Final Environmental Impact Report

# Vallco Special Area Specific Plan

SCH# 2018022021

August 2018

Figure 4: DEIR Heights

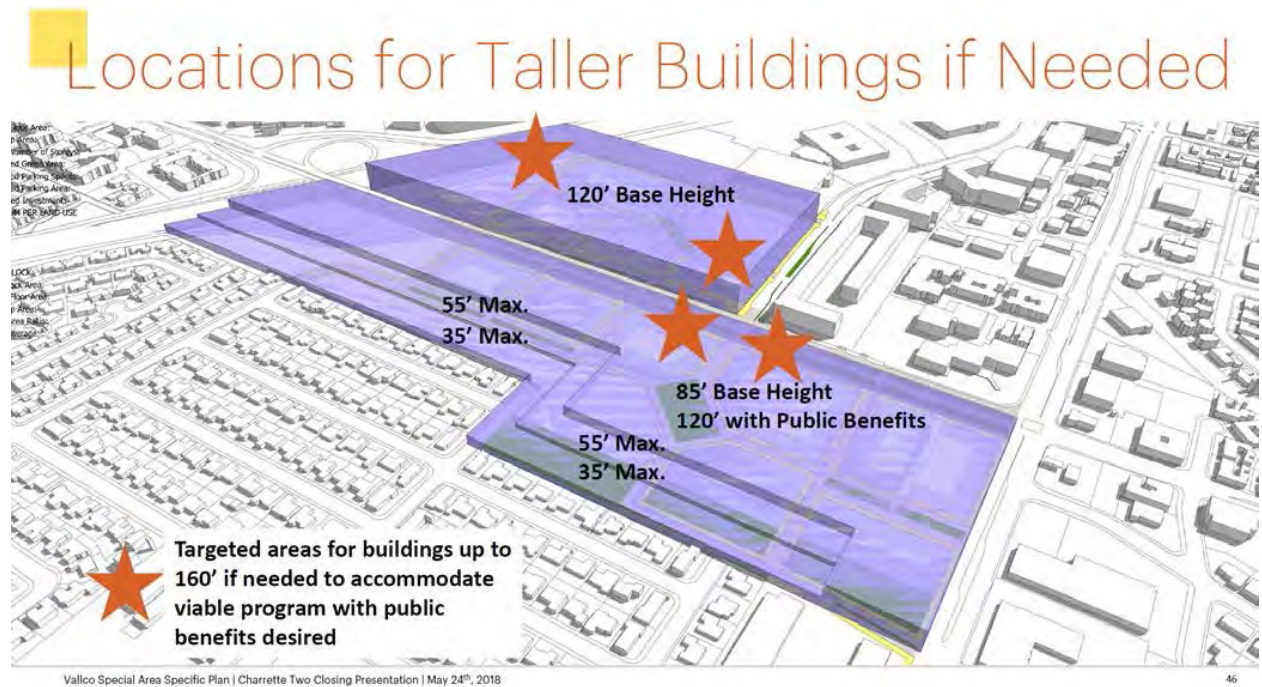
**Comment E.12:** 3. 65,000 SF of civic space, STEM lab, and 30 acre green roof were not discussed in the NOP period for Vallco. In the DEIR civic space and STEM lab are combined into the 65,000 SF. Additionally, the civic/STEM spaces are considered public benefits which would result in higher building heights if the developer includes them. This was mentioned at the Opticos Charrette #2 closing presentation, May 24, 2018:

**Response E.12:** Refer to Master Responses 2 and 3. The above figure submitted by the commenter is not the height diagram included in the Draft EIR. The maximum building heights for the previous project are described on page 11 in Section 2.4.1 of the Draft EIR and shown on Figure 2.4-3 of the Draft EIR. Under the previous project, and as discussed in the Draft EIR, the maximum height of structures on the west side of North Wolfe Road would range between 45 and 120 feet, and the maximum height of structures on the east side of North Wolfe Road would range between 90 and 145 feet.

Figure 8: Vallco Specific Plan Process Alternatives to Date (self)

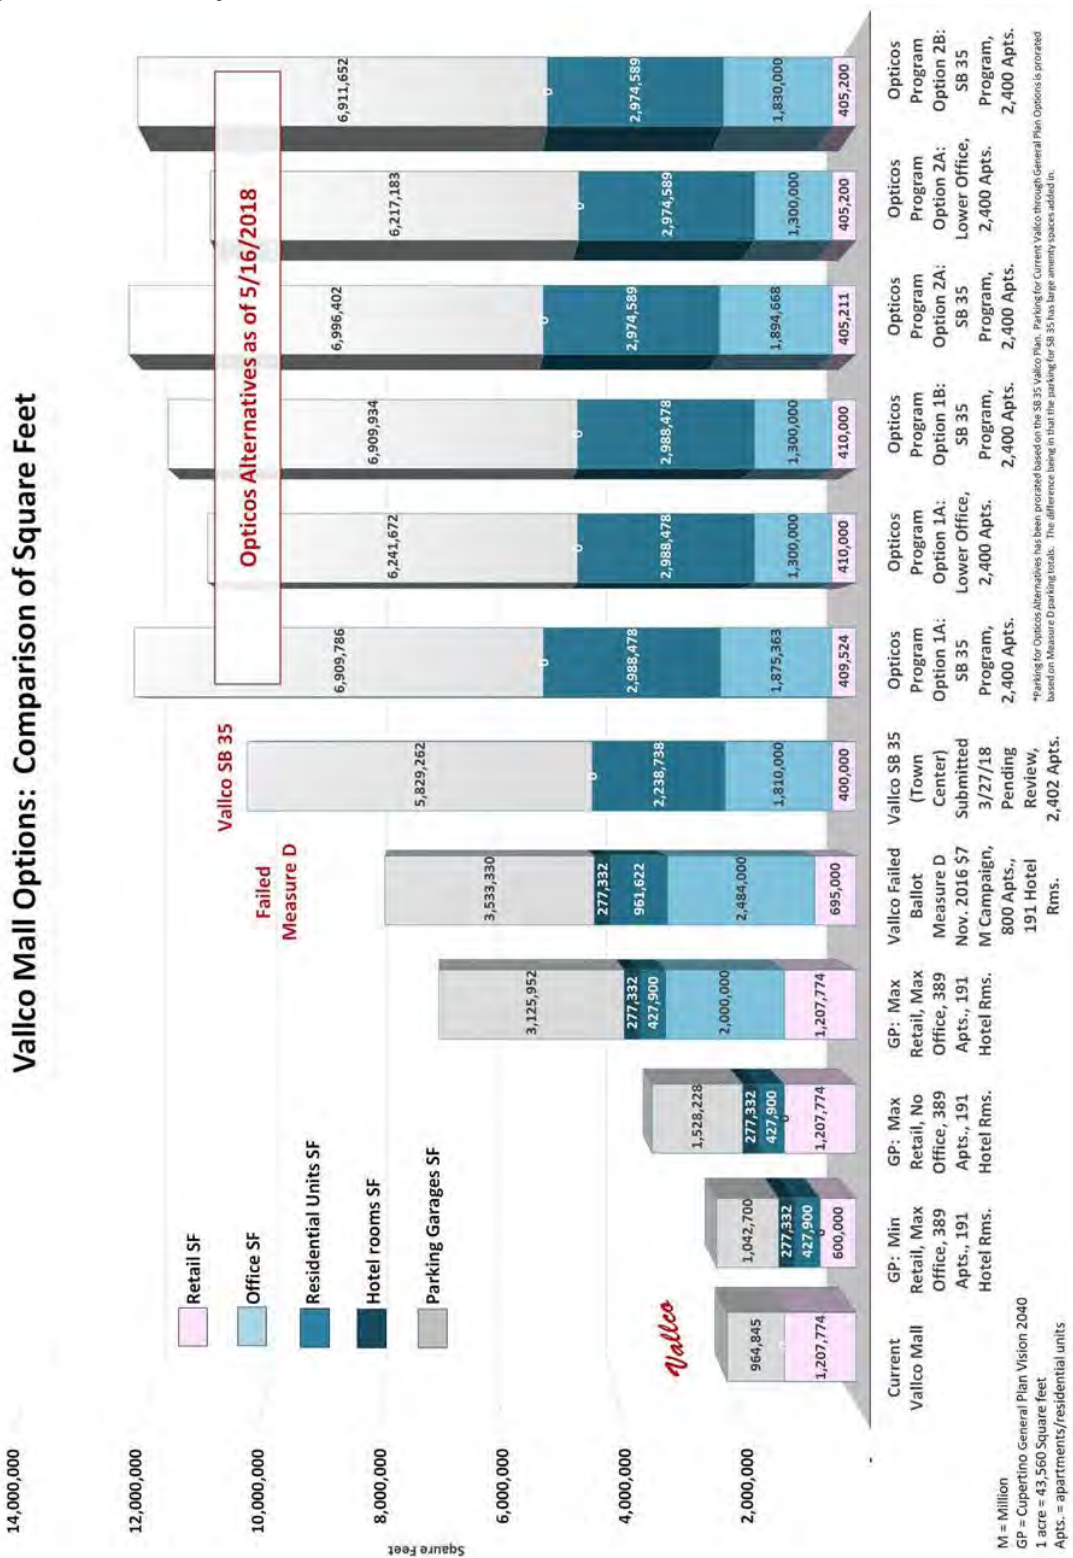
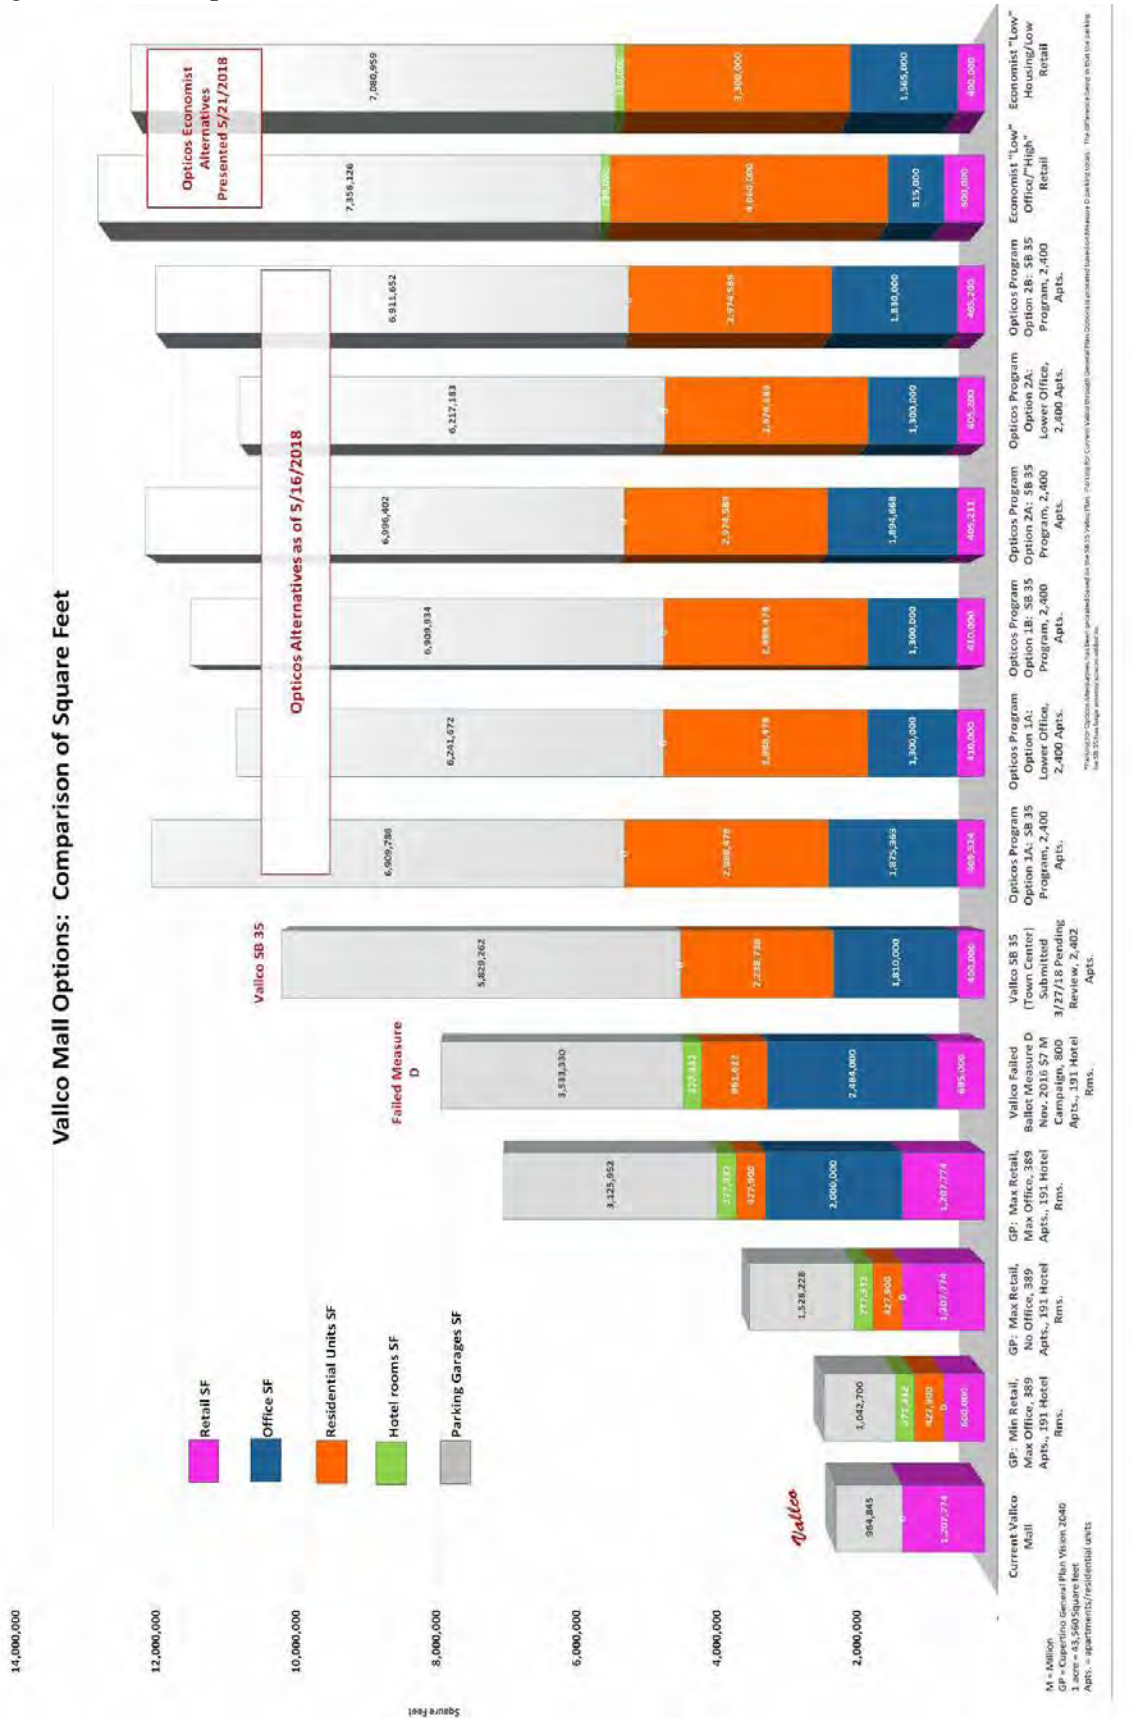
Figure 7: Vallco Project Alternatives after Charrette #1 (self)

**Response E.19:** Refer to Master Response 2 and Section 5.2 Response II.E.3. The project and project alternatives analyzed in the Draft EIR are not represented in Figures 7 and 8 submitted by the commenter. For this reason, no response regarding the accuracy of the figures is provided.

Figure 25: AQI from BAAQMD

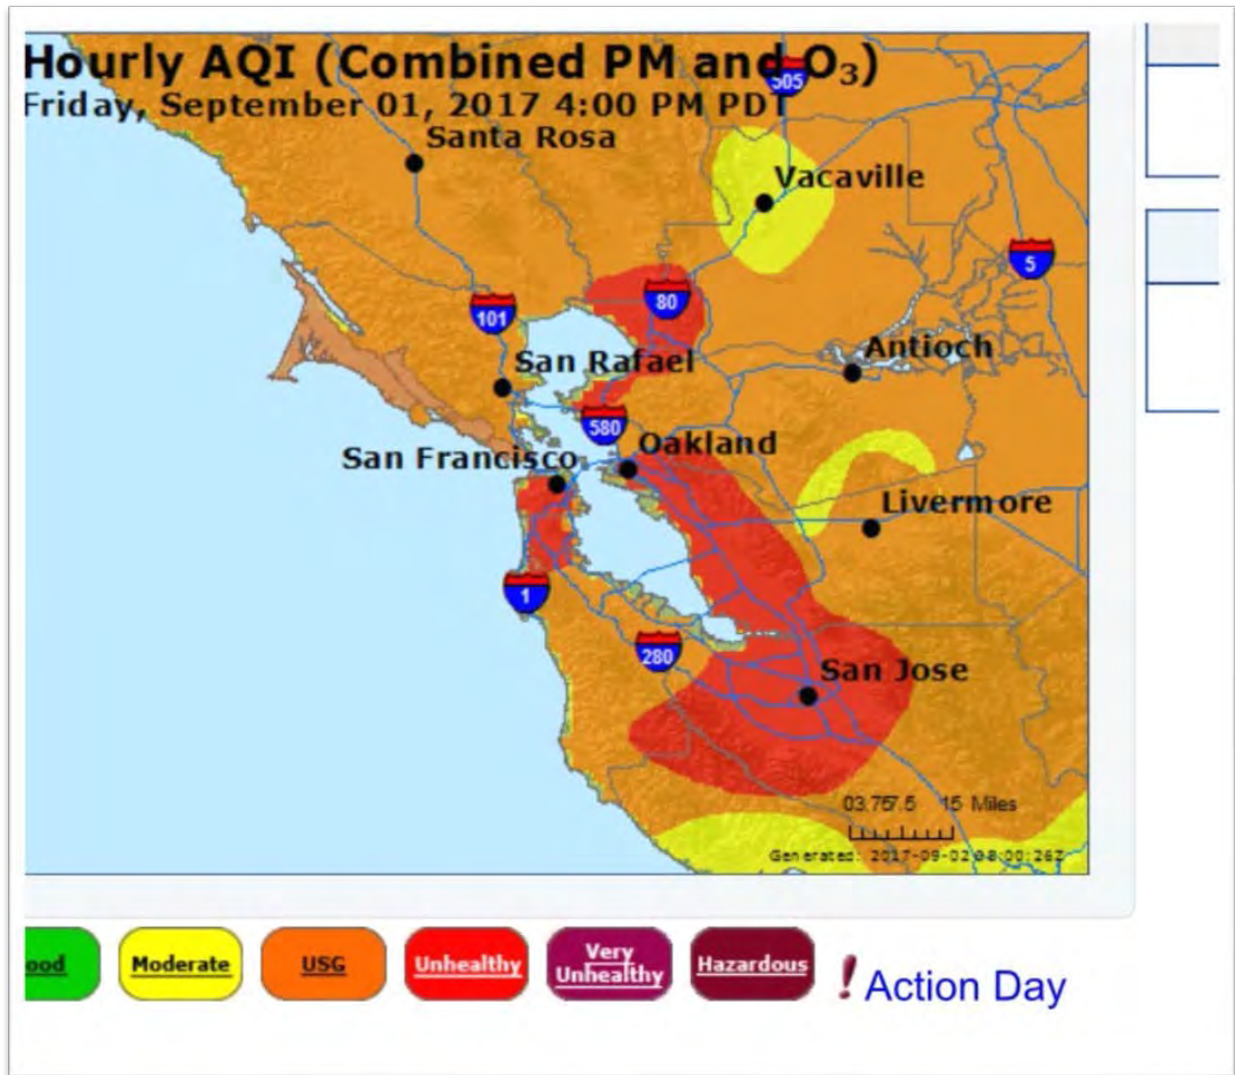
The cancer risk assessment is based on erroneous traffic studies and the air quality monitoring stations had old data from 2013 and/or were too far away to use data. The cancer risk needs to be recalculated. The amount of exposure time should reflect seniors not leaving the project area. The baseline air quality monitoring must be taken over an extended period with particular attention paid to the summer months when Ozone levels increase. Here is an example day when children would be playing outdoors, Ozone was the primary pollutant. Note these are regional amounts, and the increases along the freeways are not shown:

**Response E.53:** The impact assessment addressed under Impact AQ-7 on pages 70-80 (see also Table 3.3-7) of the Draft EIR pertains to localized emissions of toxic air contaminants (TACs) and fugitive dust that would lead to increased lifetime cancer risk and annual PM<sub>2.5</sub> concentrations. The sources of these TACS due to the Specific Plan project are construction equipment and heavy duty truck traffic that generates diesel exhaust. Construction activity affects air quality in two primary ways:

Figure 42: Opticos Charrette #2

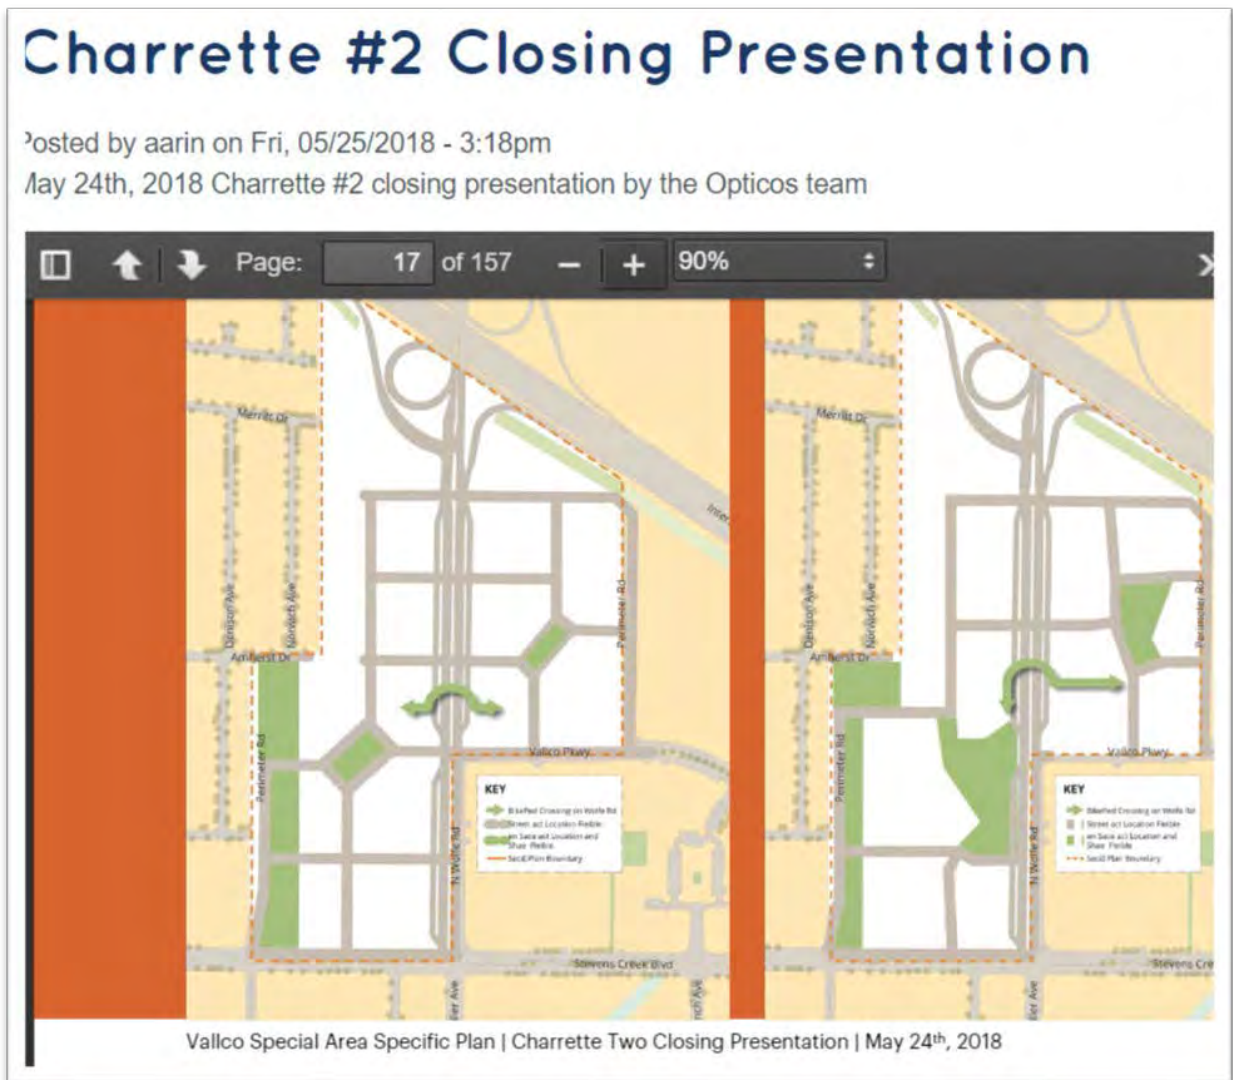
Charrette #2 Closing Presentation shows parks adjacent to back yards of single family residences. This may, combined with Perimeter Rd. noise exceed Municipal Code permissible sound levels. The DEIR does not adequately address this.

**Response E.105:** Future development is required to meet City Municipal Code noise standards. As stated on page 32 of the Draft EIR under Section 2.4.4.6 Specific Plan Assumptions (as revised in Section 5.0) and on page 222 of the Draft EIR in Section 3.13 Noise and Vibration (as revised in Section 5.0):

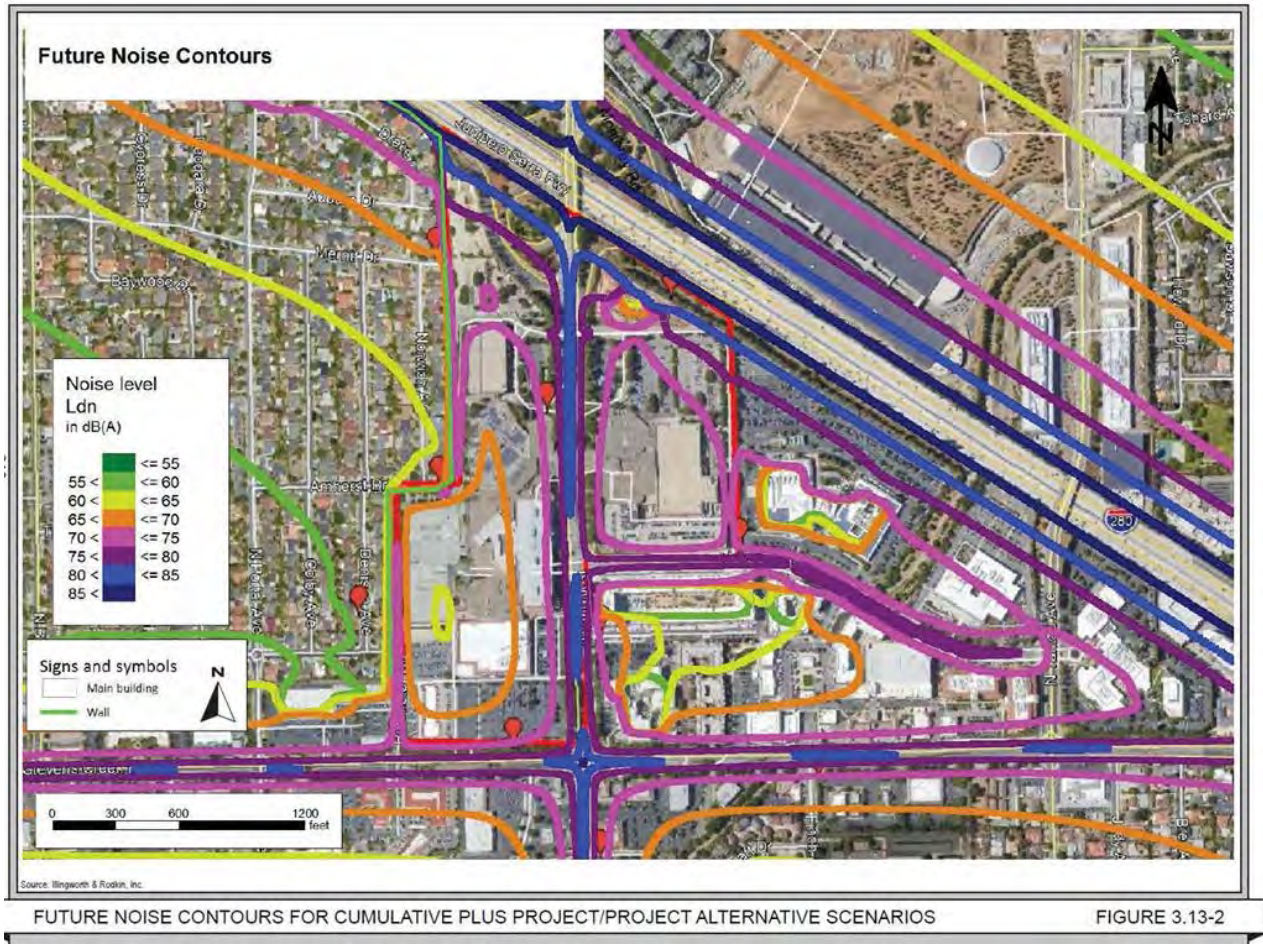
**Comment E.106: FUTURE NOISE CONTOURS**

The Future Noise Contours map has some omissions regarding noise from the Perimeter Road, western edge park, and proposed amphitheater. The map has gross assumptions regarding what the plan would look like and ignores conditions on the roof which would result in a separate layer of mapping: One layer for ground level (ear level) and one level for the roof park to see if it meets park noise requirements.

The future noise contours for the project site exceed residential maximum levels according to the Cupertino Municipal Code 10.48.040.

**Response E.106:** The excerpted Figure 3.13-2 from the Draft EIR shows noise level contours at the height of five feet above the ground only. This figure was provided to illustrate the noise from roadways and provide a guideline for future development under the Specific Plan. The level of detail and information provided in Figure 3.13-2 is appropriate for a specific plan-level analysis.

As explained above, the noise contours in Figure 3.13-2 of the Draft EIR reflect only traffic noise, and are to be used to guide future development with regards to noise and land use compatibility. The maximum permissible sound levels in the City’s Municipal Code (and shown in Figure 43 in the above comment) have a different use, which is to control noise sources on one property that affect another property (not traffic noise levels). For this reason, the City’s maximum permissible sound levels referenced in the above comment do not apply to the noise contours shown in Figure 3.13-2 in the Draft EIR.

Figure 4: DEIR Heights

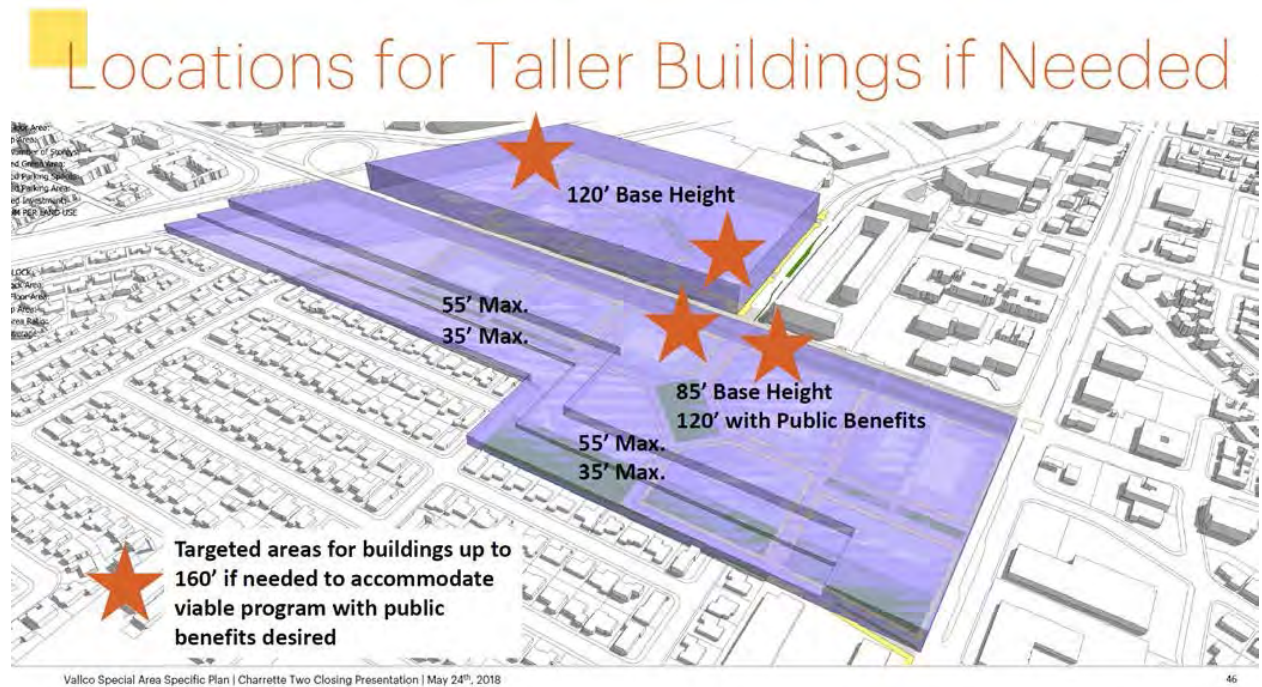
**Comment F.15:** 3. 65,000 SF of civic space, STEM lab, and 30 acre green roof were not discussed in the NOP period for Vallco. In the DEIR civic space and STEM lab are combined into the 65,000 SF. Additionally, the civic/STEM spaces are considered public benefits which would result in higher building heights if the developer includes them. This was mentioned at the Opticos Charrette #2 closing presentation, May 24, 2018:

Refer to Section 5.2 Response II.E.12.
